**VIRGINIA ELECTRIC AND POWER COMPANY**  
**NORTH ANNA POWER STATION UNITS 1 AND 2**  
**SIX-MONTH STATUS REPORT IN RESPONSE TO MARCH 12, 2012 COMMISSION**  
**ORDER MODIFYING LICENSES WITH REGARD TO RELIABLE SPENT FUEL POOL**  
**INSTRUMENTATION (ORDER NUMBER EA-12-051)**

**North Anna Power Station Units 1 and 2  
Virginia Electric and Power Company (Dominion)**

**Order EA-12-051 Interim Staff Evaluation (ISE)  
Request for Additional Information (RAI) Responses**

Figure 1 – North Anna SFP Level Instrumentation Plan View

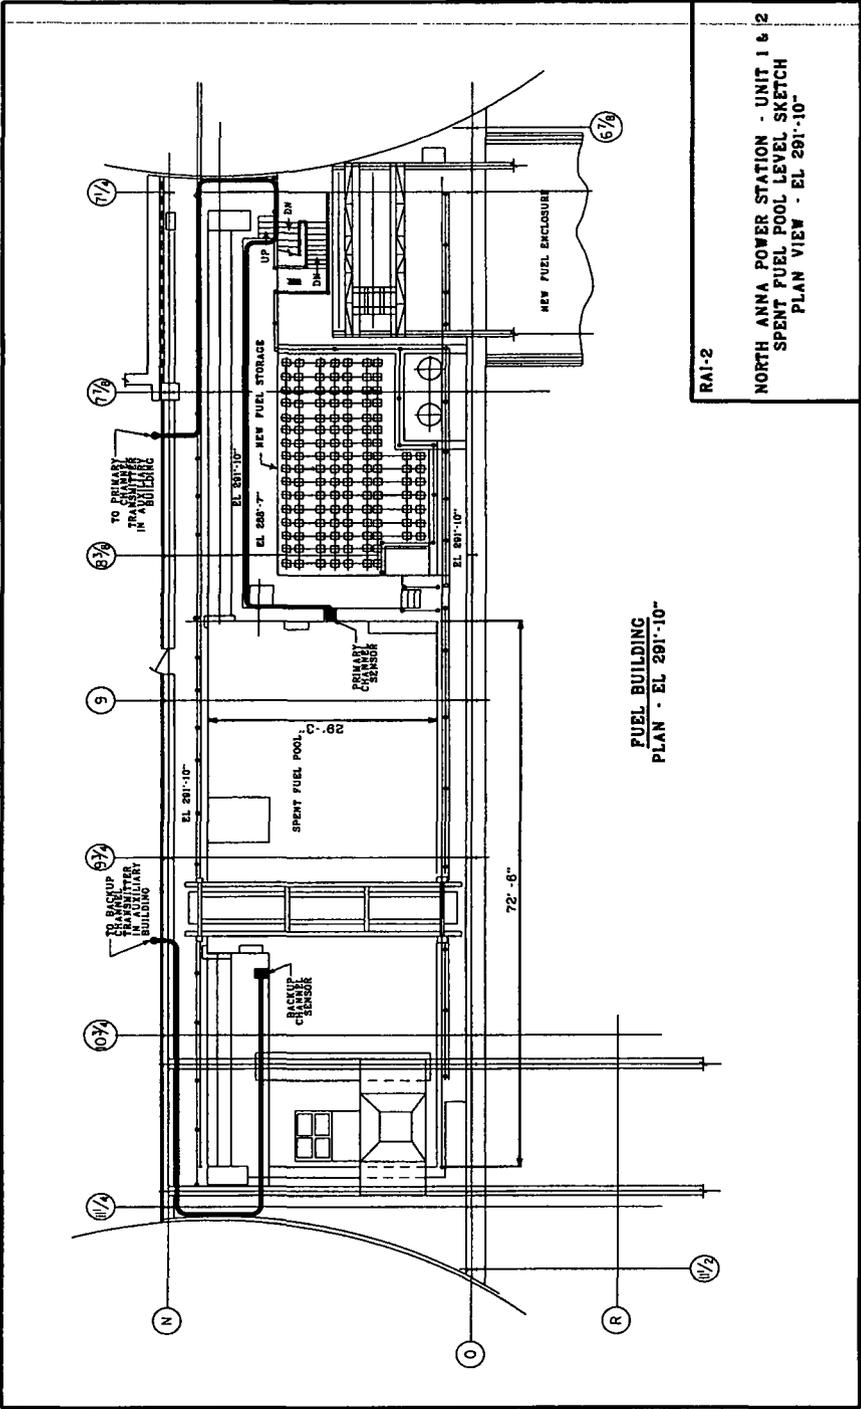
*Please provide a clearly labeled sketch or marked-up plant drawing of the plan view of the SFP area, depicting the SFP inside dimensions, the planned locations/placement of the primary and back-up SFP level sensor, and the proposed routing of the cables that will extend from these sensors toward the location of the read-out display device.*

A plan view sketch of the SFP area is provided as Figure 1 below. The sketch depicts the SFP inside dimensions, the planned locations/placement of the primary and back-up level sensors, and the proposed routing of cables that extend the sensors toward the location of the electronics.

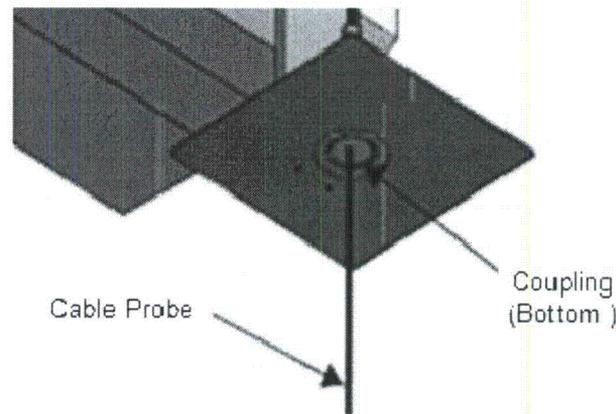
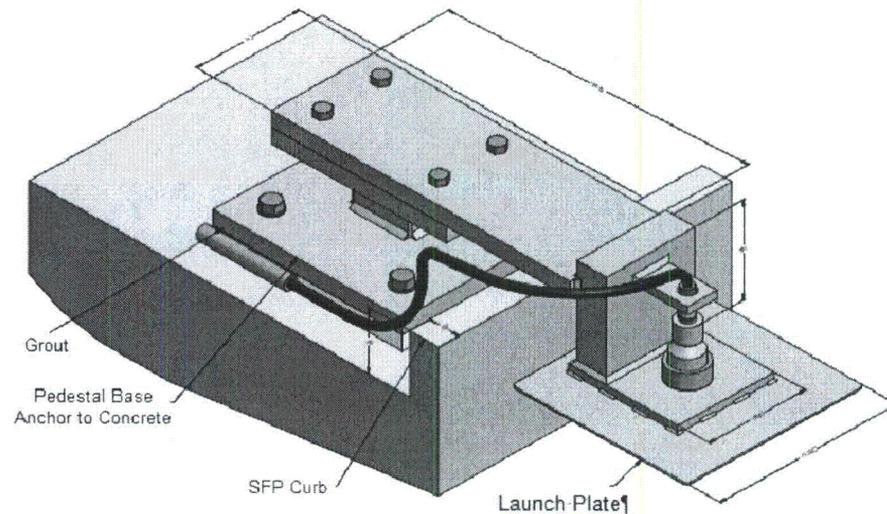
*b) A description of the manner in which the level sensor will be attached to the refueling floor and/or other support structures for each planned point of attachment of the probe assembly. Indicate in a schematic the portions of the level sensor that will serve as points of attachment for mechanical/mounting or electrical connections.*

b) The level sensor consists of a stranded stainless steel cable level probe that is threaded on the top end. The probe attaches (threads) into a coupling that is secured to the mounting bracket launch plate and extends down into the pool. The attachment to the signal cable is via a coaxial connection on the top side of the launch plate coupling. The mounting bracket is attached to the SFP structure at the concrete curb utilizing expansion-type concrete anchor bolts.

The simplified drawing below shows a representation of the attachment of the probe and the sensor cable to the mounting bracket (launch plate) , and mounting bracket attachment to the SFP structure.
